YARRA CITY COUNCIL

Internal Development Approvals Committee

Agenda

1.1 67 Type Street, Richmond - PLN16/1198 - Development of the land for the construction of two dwellings

Attachment 1 - PLN16.1198 - 67 Type Street, Richmond - Advertising Plans

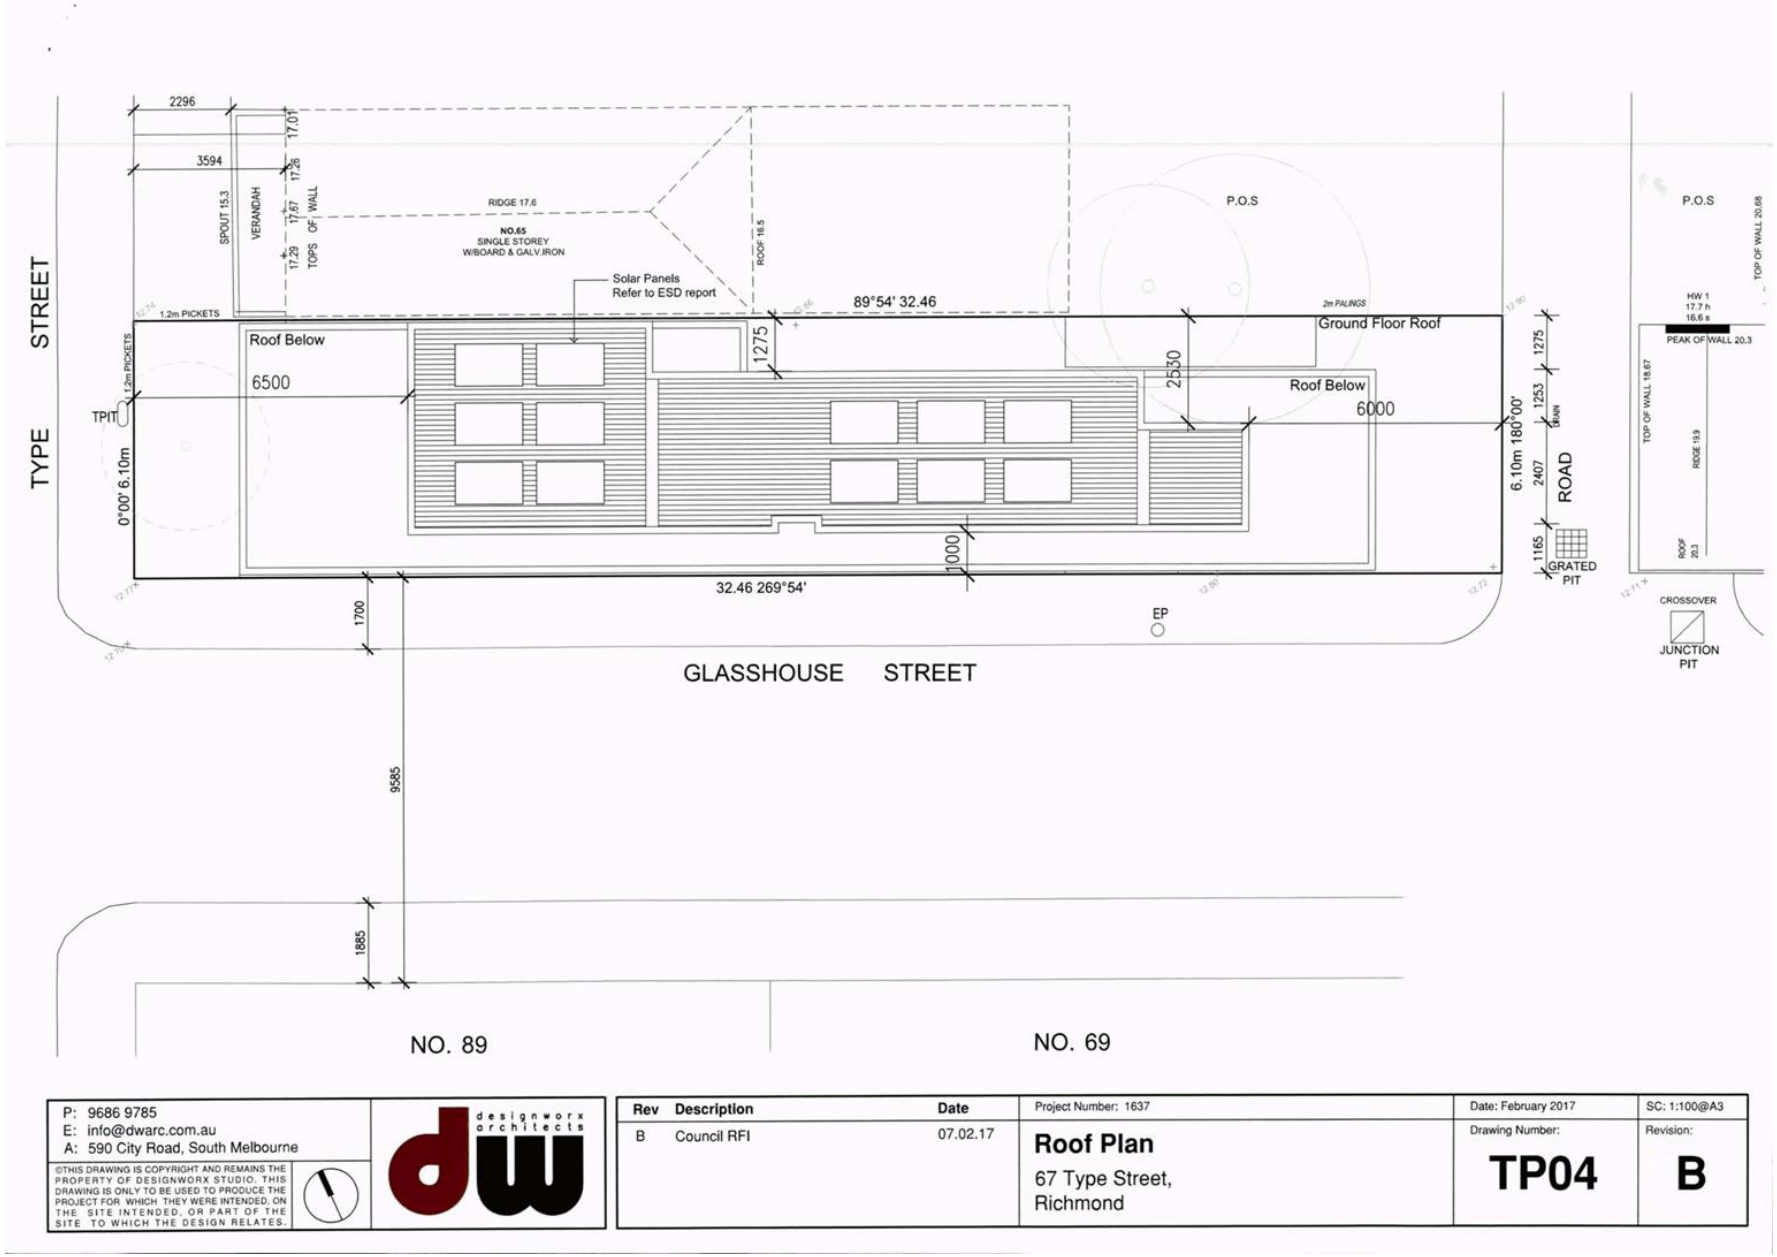
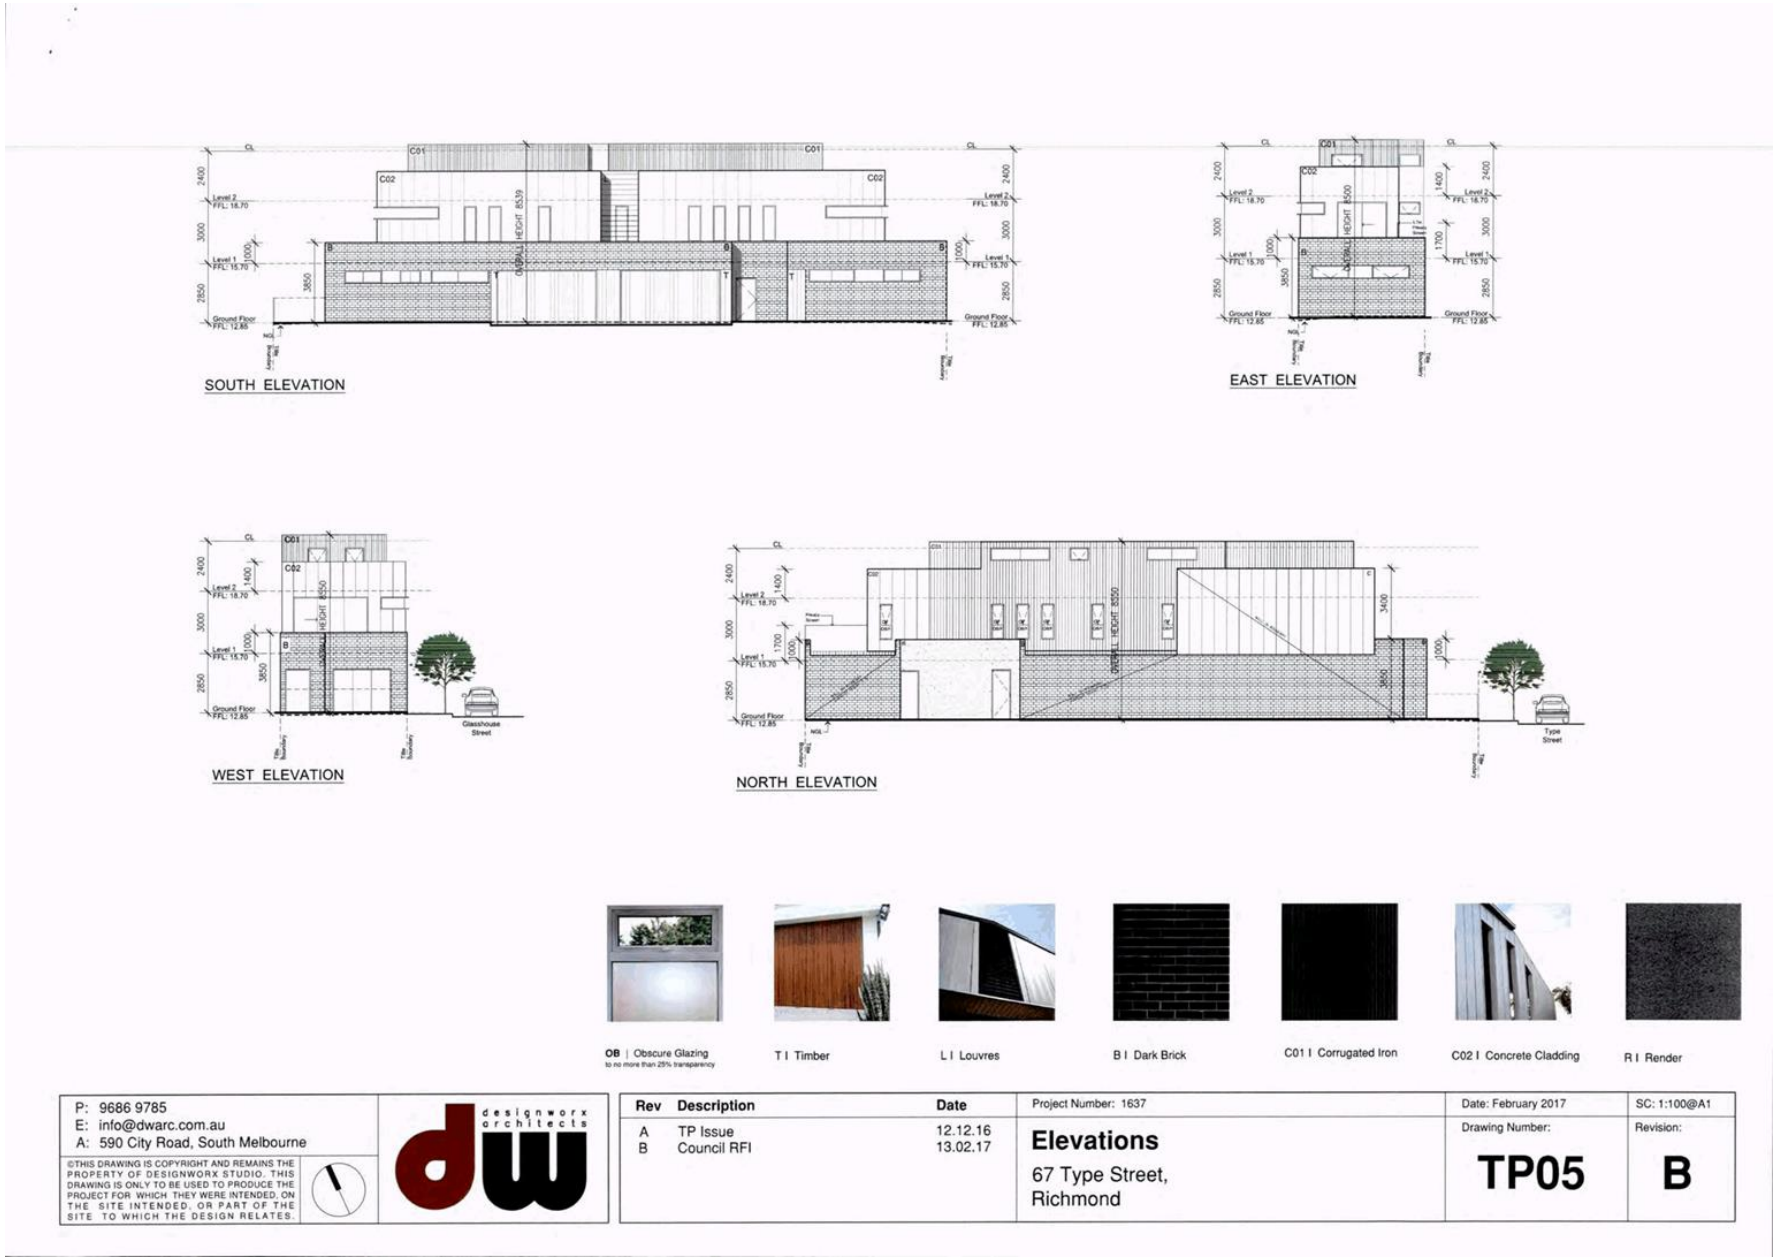
57. Concerns have been identified by Council's Urban Design Unit with respect to the triple storey built form constructed along the northern boundary with No. 65 Type Street, associated with the staircase of Dwelling 1. It is recommended that the staircase be setback 1.2m, in line with the rest of the second floor. This section of the building extends for 6.2m along the boundary and is setback 6.5m from Type Street. To provide the requested setback, the master bedroom and WIR would have to be reduced in width, identical to the setback provided to the master bedroom to Dwelling 2. It is considered that given the setback to the street (6.5m), its location adjacent to the roof of No. 65 Type Street (not a sensitive open space or habitable room window), the presence of triple storey built forms within area and use of material (white concrete cladding along the first with black corrugated iron along the second) the section of wall is acceptable in this instance.

61. Further to the above, discrepancies between the perspectives and the floor plans/elevation have been identified with respect to the provision of windows along the second floor (southern elevation). The perspective shows glazing along the second floor, with the elevation and floor plans showing a blank wall. It is considered that the provision of windows along the second level will provide a better appearance and a break in the upper floor. As such a condition will be included for the provision of fenestration to the second floor, southern elevation.

82. Council's ESD Officer reviewed the submitted Sustainable Management Plan (SMP) and STORM report which is deemed to largely provide an appropriate response. Concerns have been raised in relation to the extent of glazing along the northern, eastern and western elevations and possible high levels of heat gain as a result.

83. It has been recommended that, *"all glazing exposed to summer sun angles be protected by some external adjustable blinds, retractable awnings, louvers, shutters or similar that can provide shade from summer sun angles".* A condition will be included to reduce the level of solar heat gain, to the satisfaction of Council.

1. Before the development commences, amended plans to the satisfaction of the Responsible Authority must be submitted to and approved by the Responsible Authority. When approved, the plans will be endorsed and will then form part of this permit. The plans must be drawn to scale with dimensions, and three copies must be provided. The plans must be generally in accordance with the decision plans but modified to show:
